Re: A request by Robert Kauth for approval of the Final Plat of Kauth's 3rd Addition, a seven (7) acre tract into eight (8) residential lots located west of 95th Avenue and south of Hickory Hills Second Annex in part of the NE¹/₄SW¹/₄ of Section 15, Buffalo Township.

PLANNING & ZONING COMMISSION
STAFF REPORT
September 20, 2016

Request: Final Plat of Kauth's 3rd Addition, a proposed eight (8) lot residential subdivision.

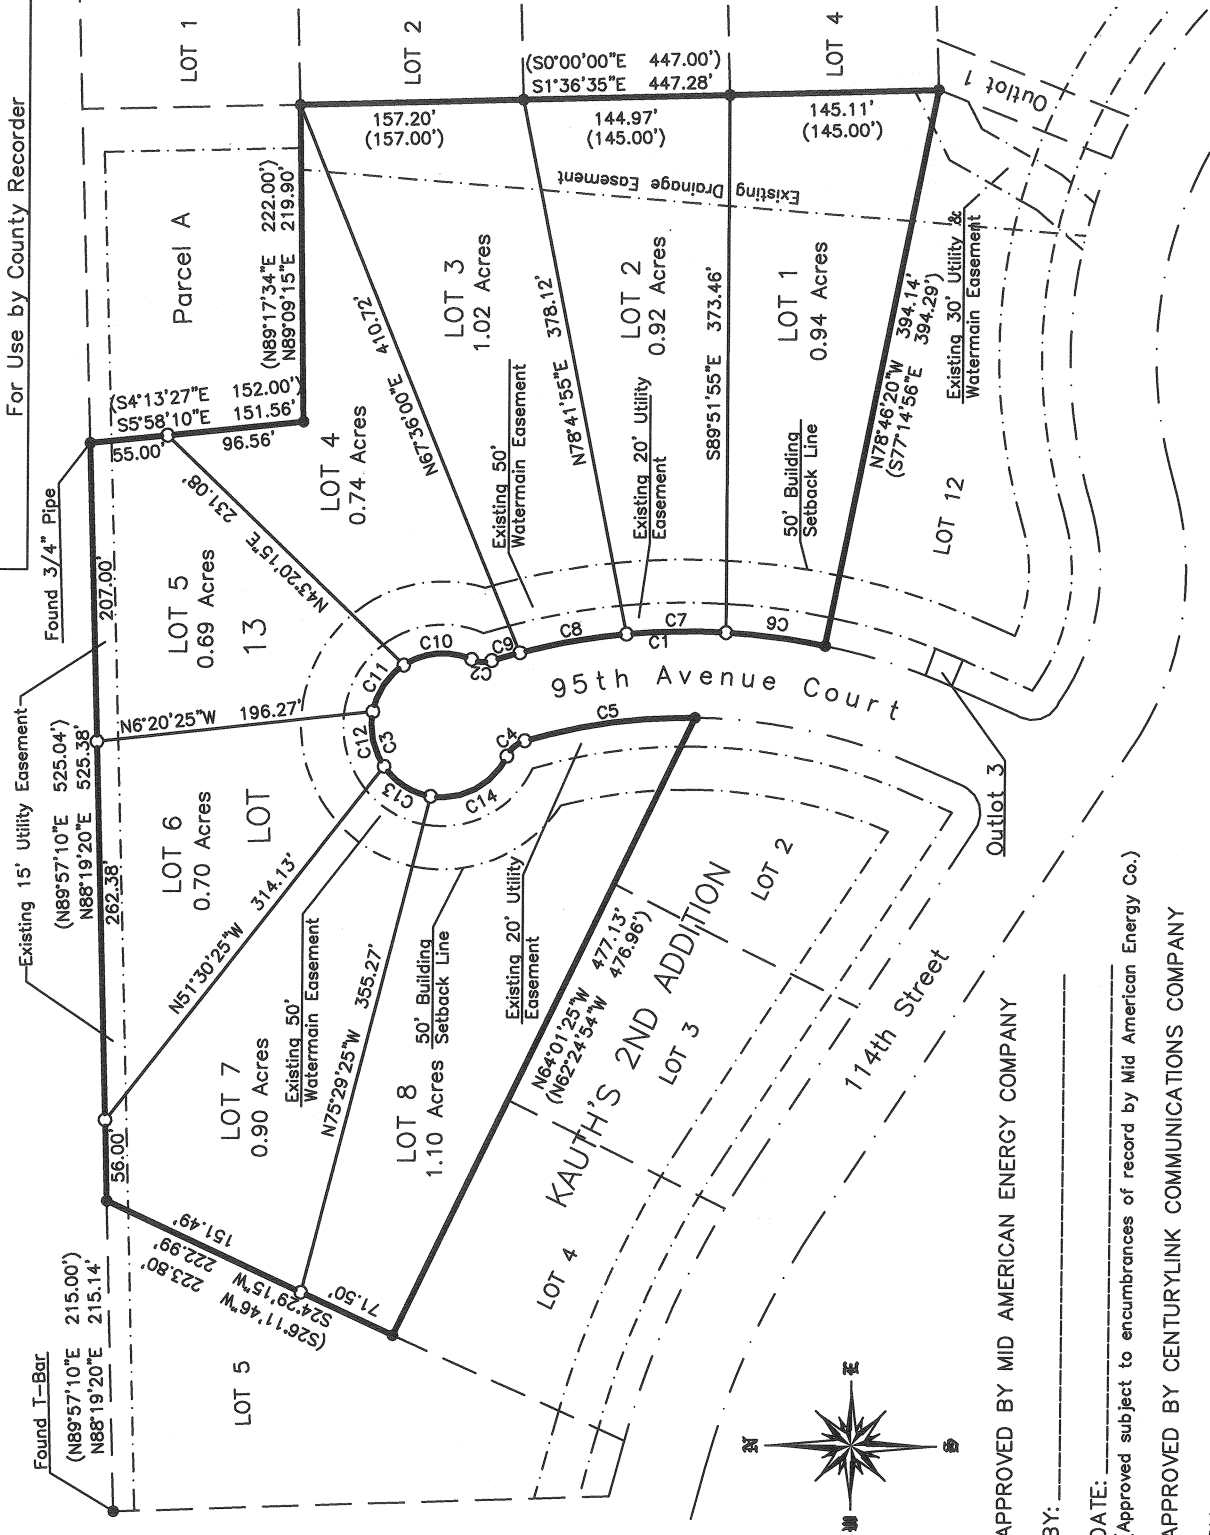
This Final Plat is for eight (8) lots rather than nine (9), as was approved with the Preliminary Plat. Since this minor change is a reduction in density staff determined the Final Plat could be approved as submitted.

The County Engineer states that the new roads, 114th Street and 95th Avenue Court, appear to have been adequately constructed. However the County Engineer does state that he has concerns that he never received, reviewed or approved any final construction plans for that road. He did review Preliminary Plans and he states that the road construction appears to match those plans. He also states that the grades for 114th Street are nearly 7% in spots which was steeper than was shown on the plans. Finally he states that the road design is not consistent as far as the use of curb and gutter and that the standard for the County to accept subdivision roads is that they have curb and gutter throughout. He states that this would influence his recommendation on whether the County Board should accept these roads onto the County's system.

As far as the other conditions of Preliminary Plat approval, the grading and road construction have complied with the erosion and sediment control plan; the permitted areas for residences and accessory buildings are delineated on the Final Plat; and all proposed wastewater treatment facilities will meet Health Department requirements at the time houses and septic systems are constructed on each lot.

RECOMMENDATION: Staff recommends that the Final Plat for Kauth's 3rd Addition be approved.
